Access Compliance Report

Public Rights-of-Way

(Curb Ramps)

Intersection ID: N/A	Main Street: ARLYN_CR	Cross Street: OLD_CONCORD_RD	Location: NW
ADA ID: C8E8A2924889	Ramp Type: PerpDiag	Initial Pass/Fail: Fail	Overall Compliance: No
		Severity Score: 13.75

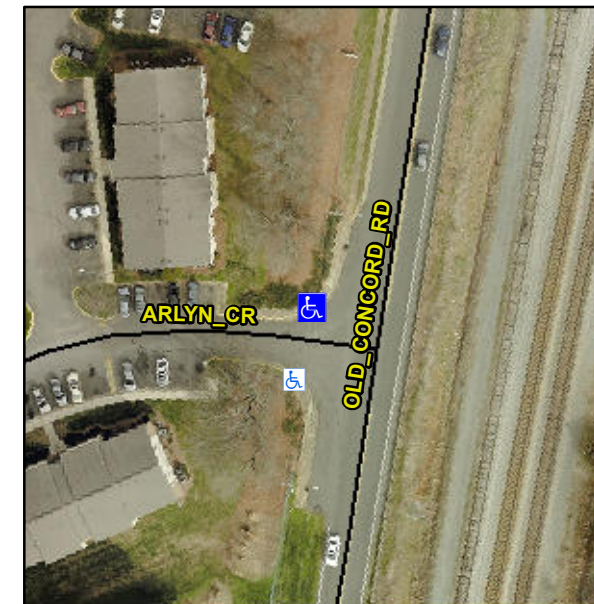
R304.2.2, R304.5.3

Compliance	Description	Data	Compliance	Description	Data
N/A	Ramp Length (in)	47.0	No	Ramp Slope (%)	11.2
Yes	Ramp Width (in)	60.0	No	Ramp XSlope (%)	2.8
N/A	Flare Type LT	N/A	N/A	Flare Type RT	N/A
N/A	Flare Slope LT (%)	N/A	N/A	Flare Slope RT (%)	N/A
N/A	Flare Traversable LT?	N/A	N/A	Flare Traversable RT?	N/A
N/A	Landing Length (in)	N/A	N/A	DWS Provided?	N/A
N/A	Landing Width (in)	N/A	N/A	DWS Contrast?	N/A
N/A	Landing Slope (%)	N/A	N/A	DWS Length (in)	N/A
N/A	Landing X Slope (%)	N/A	N/A	DWS Full Width?	N/A
N/A	Landing Curb? (Y/N)	N/A	N/A	DWS Offset (in)	N/A
N/A	Shared Landing?	N/A			
N/A	Gutter Ponding?	N/A	N/A	Gutter Slope (%)	N/A
N/A	Gutter Lip Ht (in)	N/A	N/A	Gutter X Slope (%)	N/A
N/A	Painted X Walk1?	No	N/A	Painted X Walk2?	No
	X Walk 1 Direction	To S		X Walk 2 Direction	To E
N/A	X Walk 1 Width (in)	N/A	N/A	X Walk 2 Width (in)	N/A
	X Walk 1 Slope (%)	3.3		X Walk 2 Slope (%)	0.6
	X Walk 1 X Slope (%)	0.4		X Walk 2 X Slope (%)	2.6

Remove & Replace Curb Ramp With Two New Directional Ramps or Equivalent.
